CNL-17-070

Clinch River Nuclear Site
NRC Docket No. 52-047

Subject: Submittal of Supplemental Information Associated with Hydrologic Engineering in Support of the Clinch River Nuclear Site Early Site Permit Application

Supplemental Information Regarding Site Safety Analysis Report Section 2.4, "Hydrologic Engineering"

Figure 2.4.3-17. Unit Hydrographs, Sub-basins 7, 8, 16-18, & 23-24 (Sheet 5 of 8)

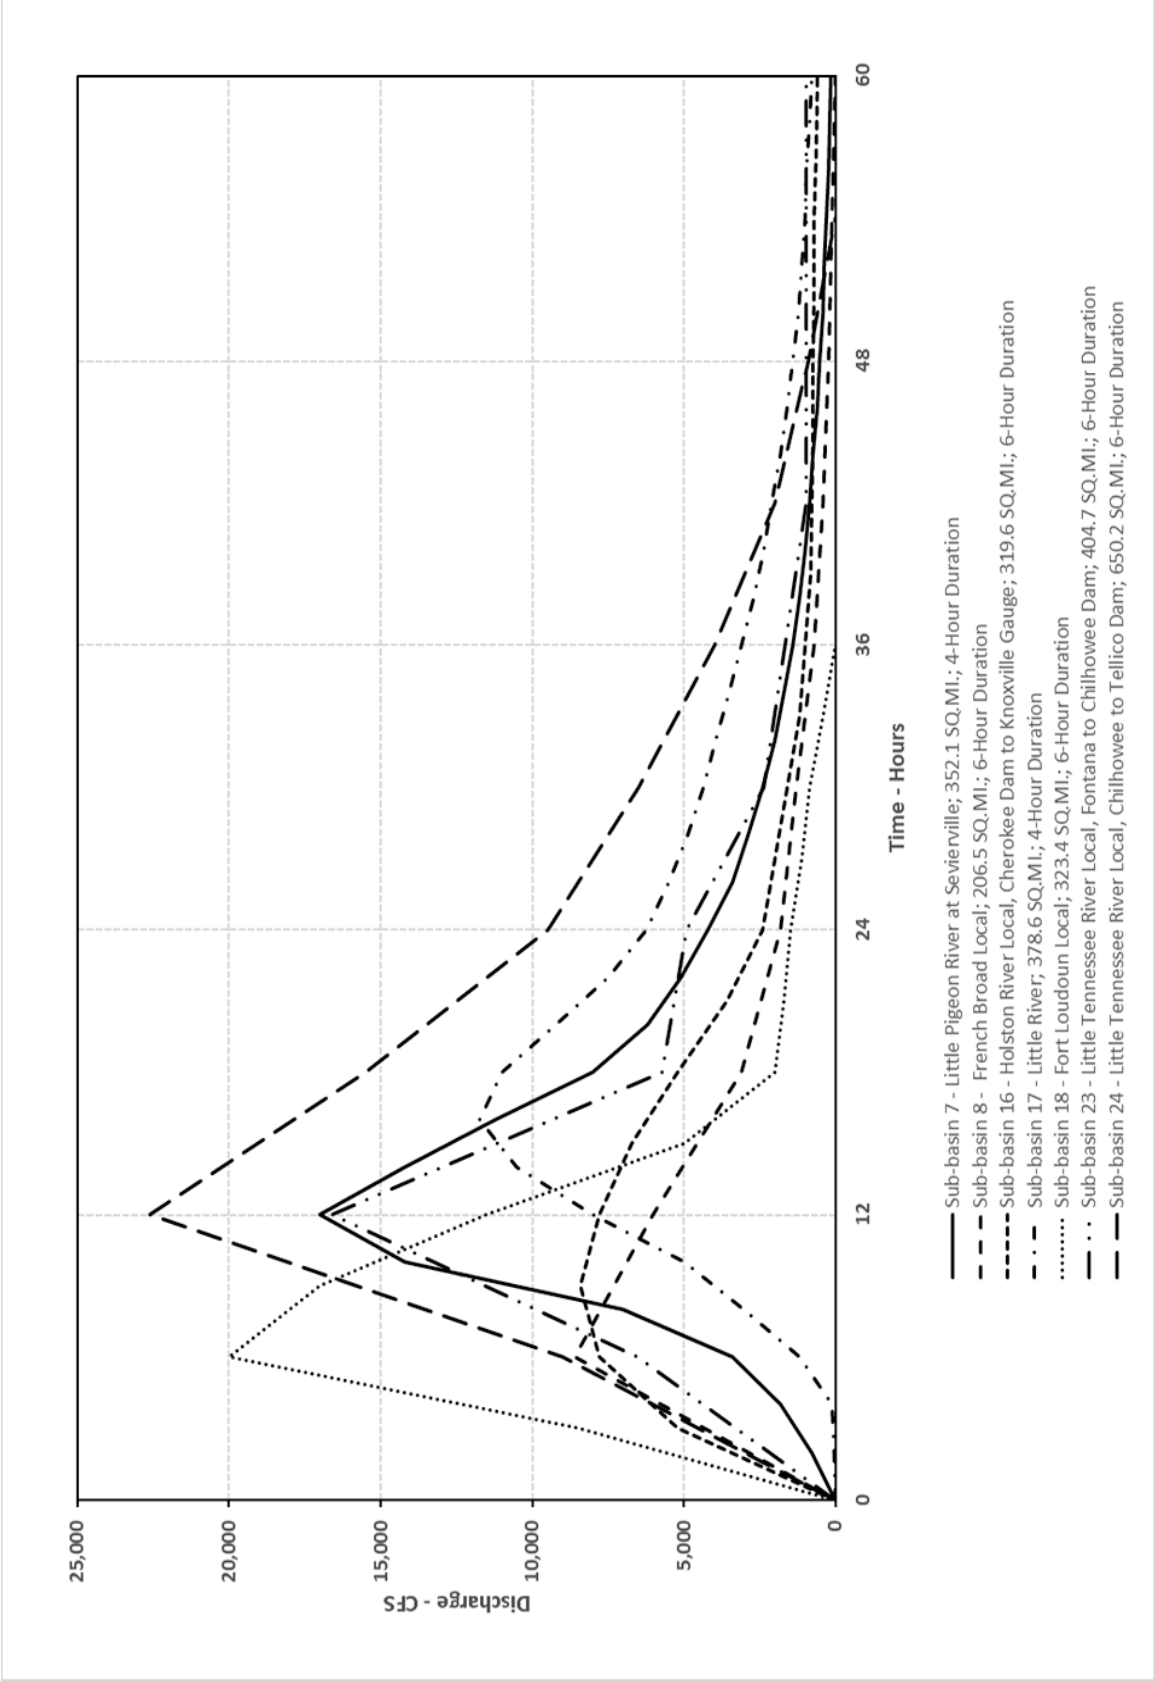
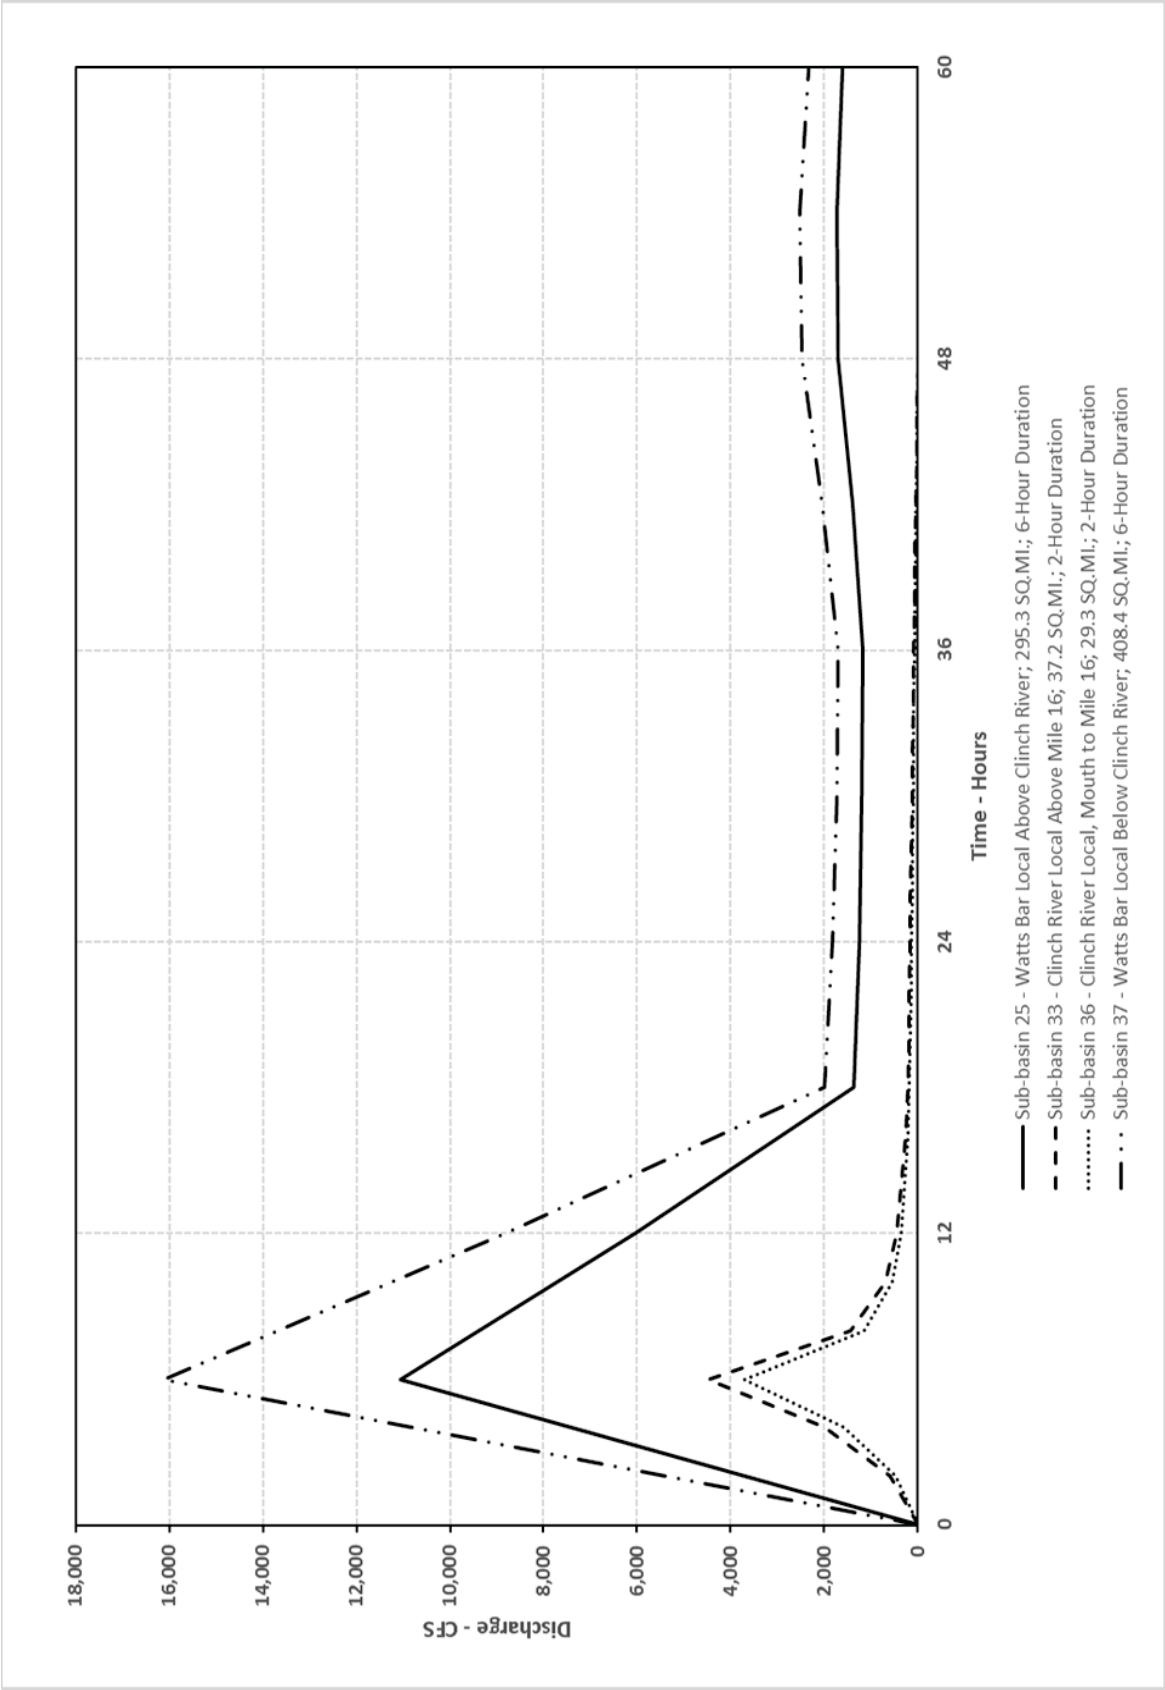
A discussion of how the Unit Hydrographs (UHs) were developed, including validation of the UH's is being added, under a subheading titled "Unit Hydrograph Development and Validation," to SSAR Subsection 2.4.3.4.1, "Runoff Model." Validated unit hydrograph figures and reference to those figures are also being added with this revision. In addition, a discussion of how the inflows were determined for the 1973/2003 storms used in the calibration is being added to SSAR Subsection 2.4.3.4.3, "Stream Course Model Geometry Development and Calibration." For these changes, see the markup provided in SSAR Subsection 2.4.3.4.1, subheading "Unit Hydrograph Development and Validation," addition of new Figures 2.4.3-17, Sheets 1 through 8, and Figures 2.4.3-18, 2.4.3-19, and 2.4.3-20, and SSAR Subsection 2.4.3.4.3, the eighth paragraph, in Attachment 3.

Figure 2.4.3-18. NID Inflow Hydrograph, Norris Reservoir

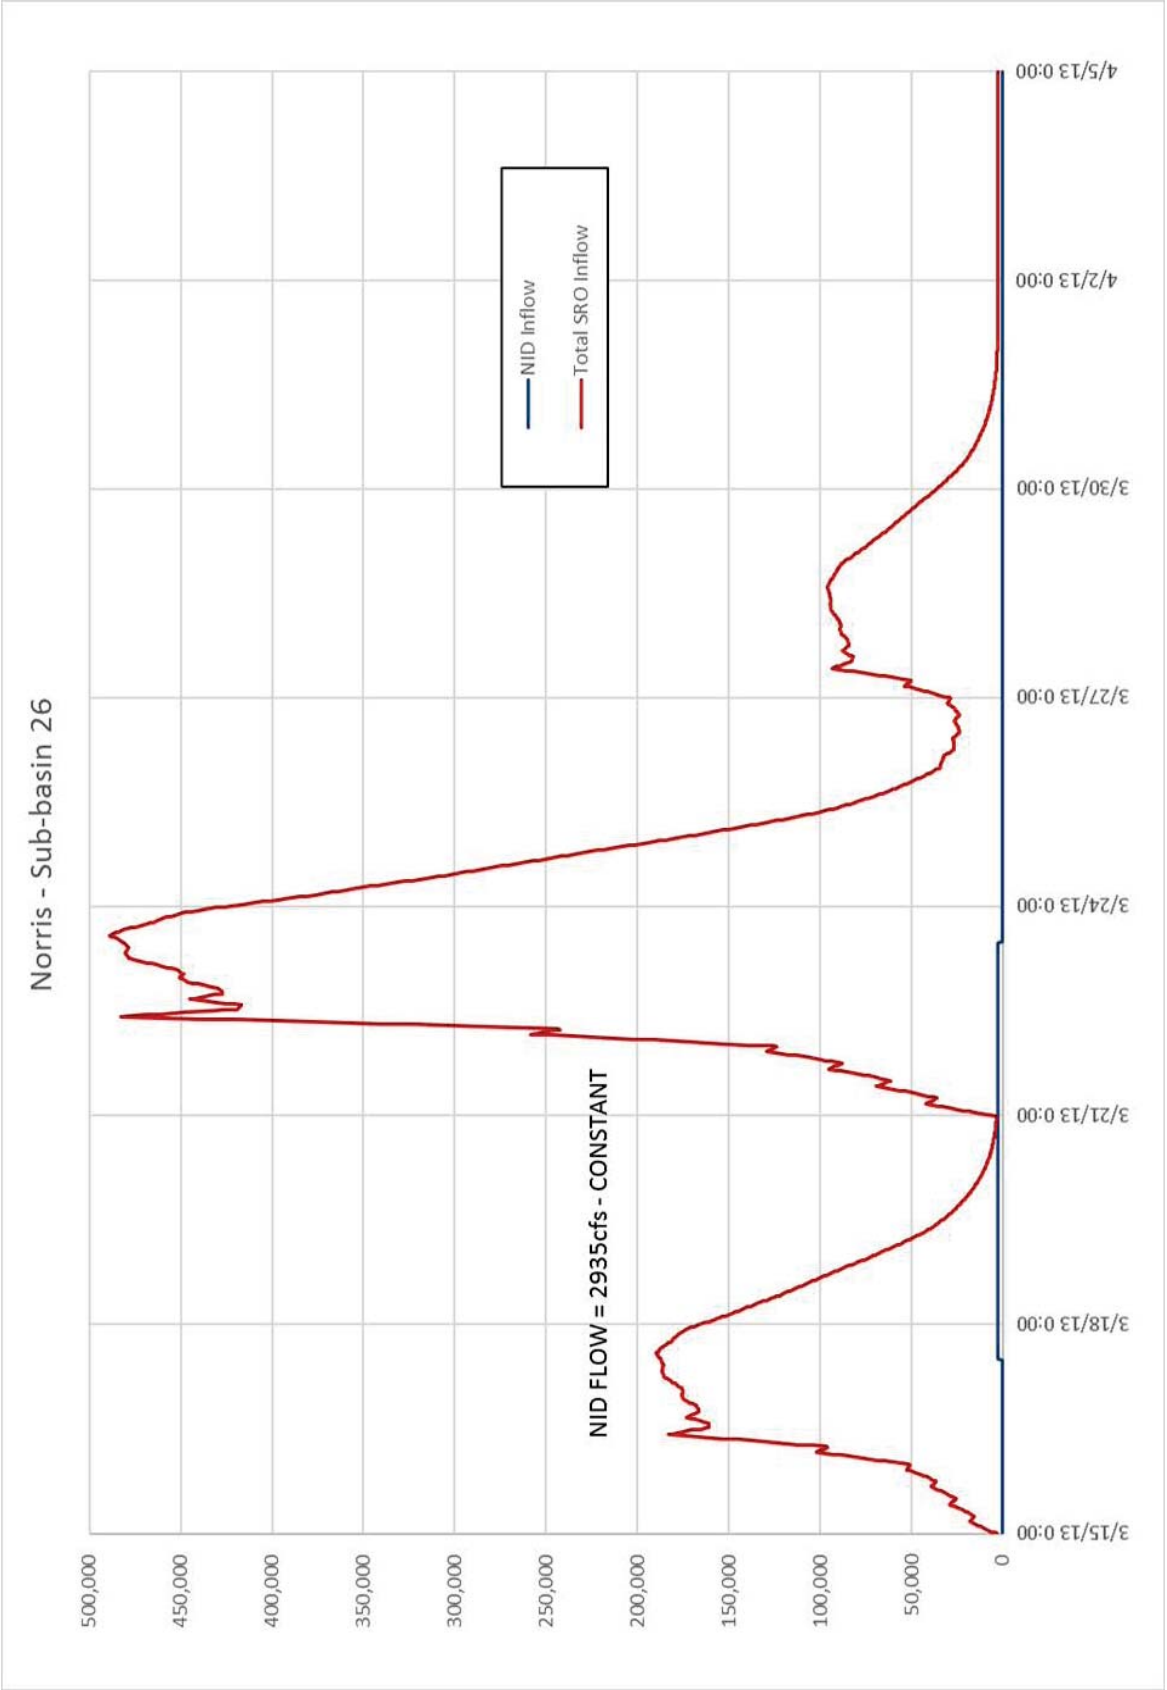
A clarification of how the storage volume from NID dams was used to develop inflow hydrographs is being added to SSAR Subsection 2.4.3.4.1, "Runoff Model," under the new subheading "National Inventory of Dams (NID) Considerations." See the markup provided in SSAR Subsection 2.4.3.4.1, under the new subheading "National Inventory of Dams (NIS) Considerations," in Attachment 3.

Figure 2.4.3-21. Highway 58 Bridge Profile

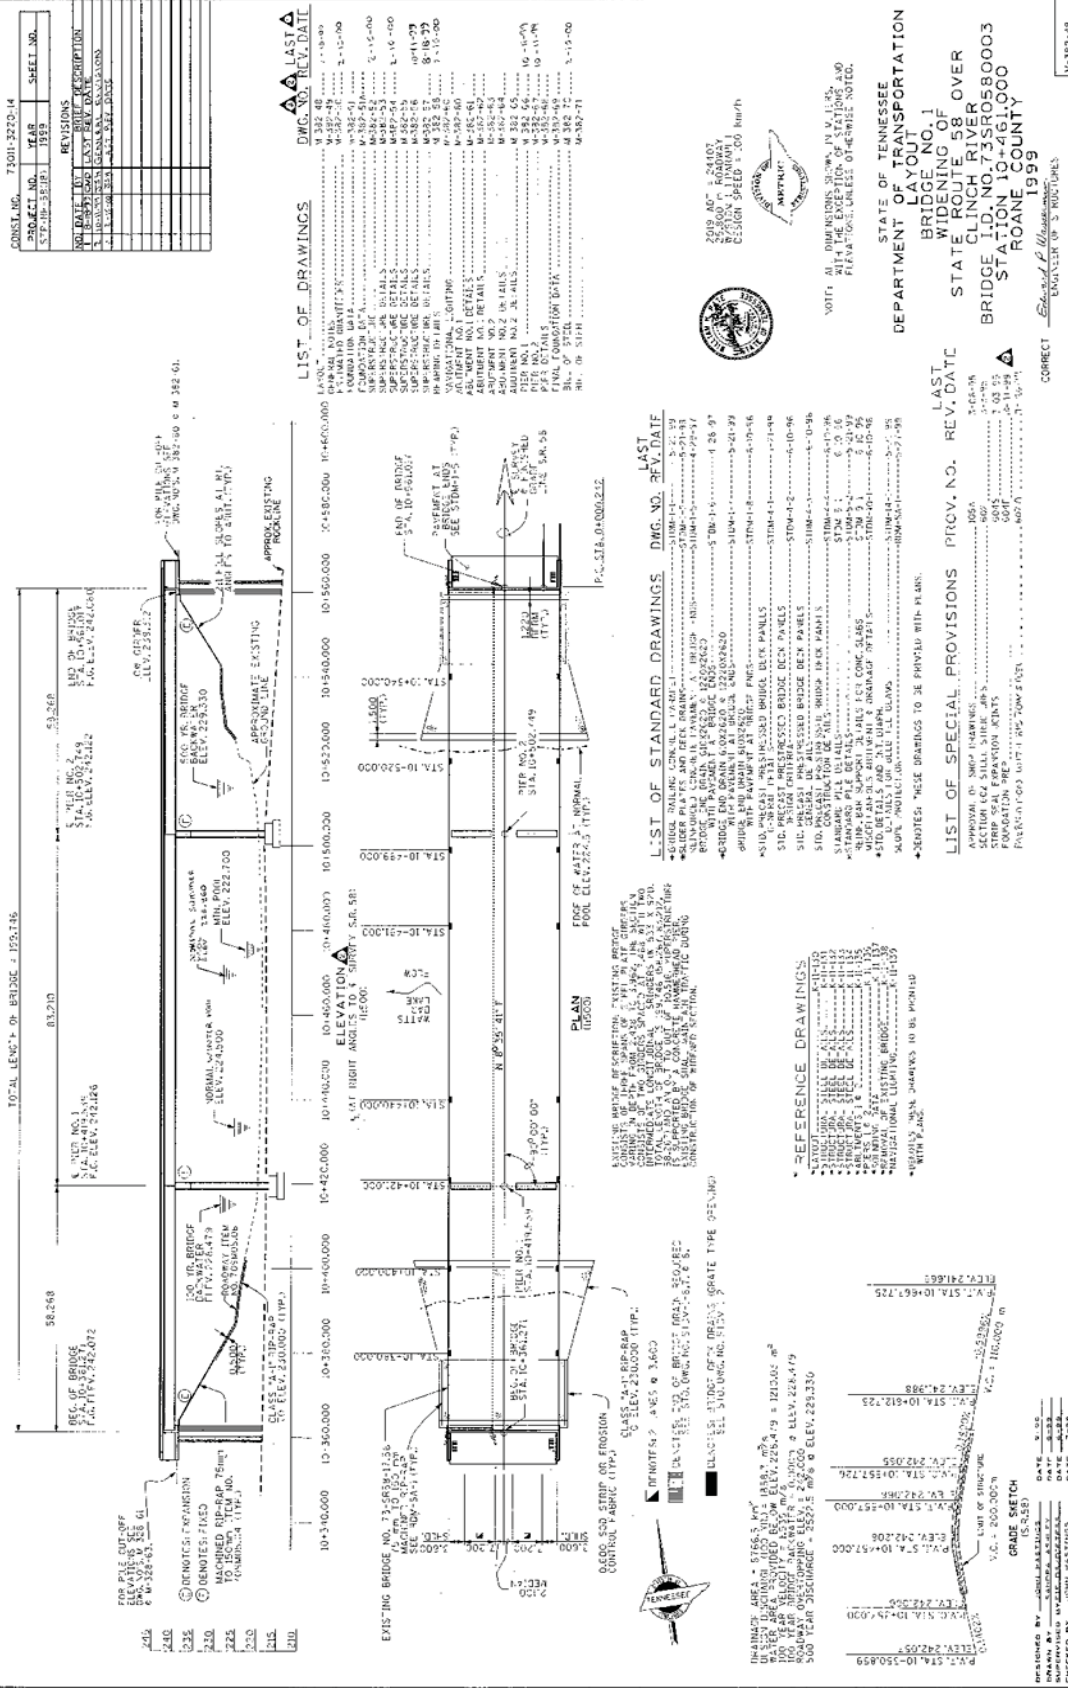
A discussion of the Highway 58 bridge sensitivity analysis and the results/conclusions is being added to SSAR Subsection 2.4.3.4.3, "Stream Course Model Geometry Development and Calibration." In addition, a figure depicting the Highway 58 bridge profile is being added to the SSAR and reference to the Figure is being included in the SSAR Subsection 2.4.3.4.3 discussion. See the markup provided in SSAR Subsection 2.4.3.4.3, fourth paragraph, and addition of new Figure 2.4.3-21, "Highway 58 Bridge Profile," in Attachment 3.

The Highway 58 bridge (Figure 2.4.3-21) near Clinch River Mile (CRM) 14 was not included in the HEC-RAS geometry because the impact was considered to not be significant. A sensitivity analysis was performed by inserting additional cross-sections at the Highway 58 bridge location based upon bridge drawing obtained from the Tennessee Department of Transportation and surrounding topography. The sensitivity analysis indicated a negligible impact (less than 0.1 ft) at the CRN Site.

Figure 2.4.3-22. Norris Reservoir Volume versus Elevation

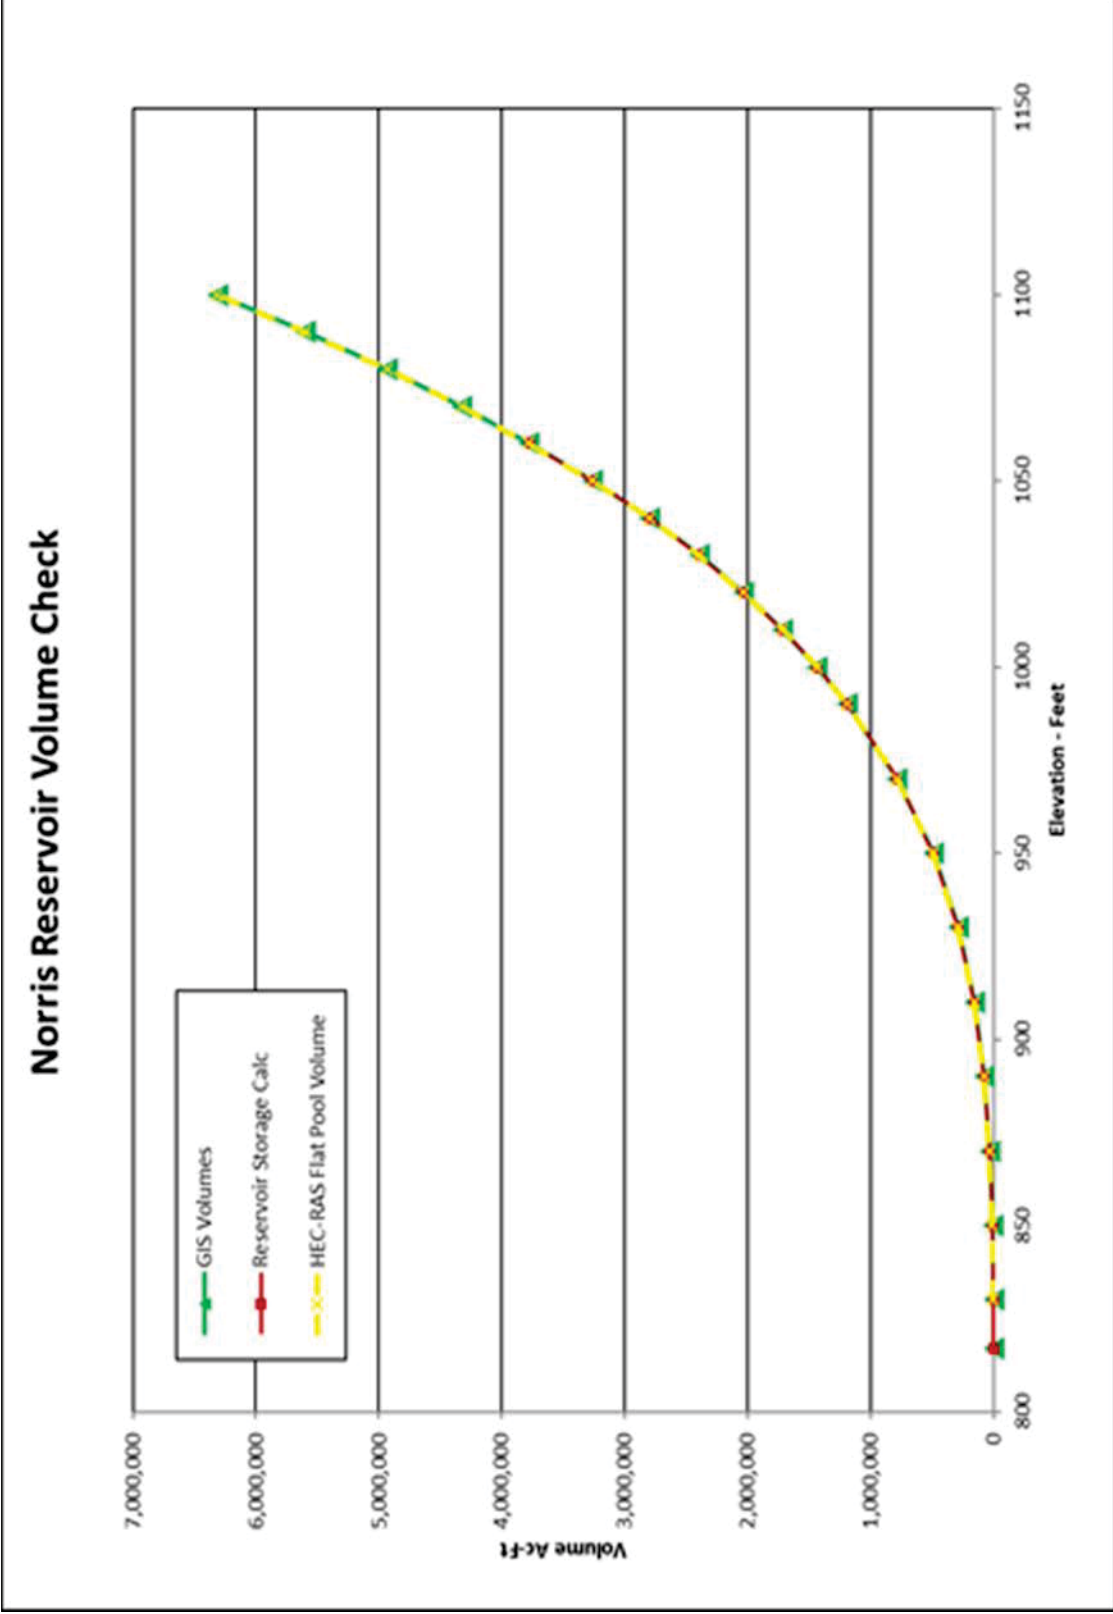
SSAR Subsection 2.4.3.4.3, "Stream Course Model Geometry Development and Calibration," and Subsection 2.4.3.4.4, "Design Storm Implementation," are being revised to add sufficient detail on the development of the HEC-RAS model, including a discussion of ineffective flow, impact of new fill on storage capacity, and new fill above PMF and away from the conveyance channel. In addition, figures depicting the reservoir storage curves and reference to the reservoir storage curves are being included in Subsection 2.4.3.4.3. See the markup provided in SSAR Subsections 2.4.3.4.3, first, second, fourth, and fifth paragraphs and 2.4.3.4.4, first and fifth paragraph, and new Figures 2.4.3-22, "Norris Reservoir Volume versus Elevation," 2.4.3-23, "Melton Hill Reservoir Volume versus Elevation," and 2.4.3-24, "Watts Bar Reservoir Volume versus Elevation," in Attachment 3.
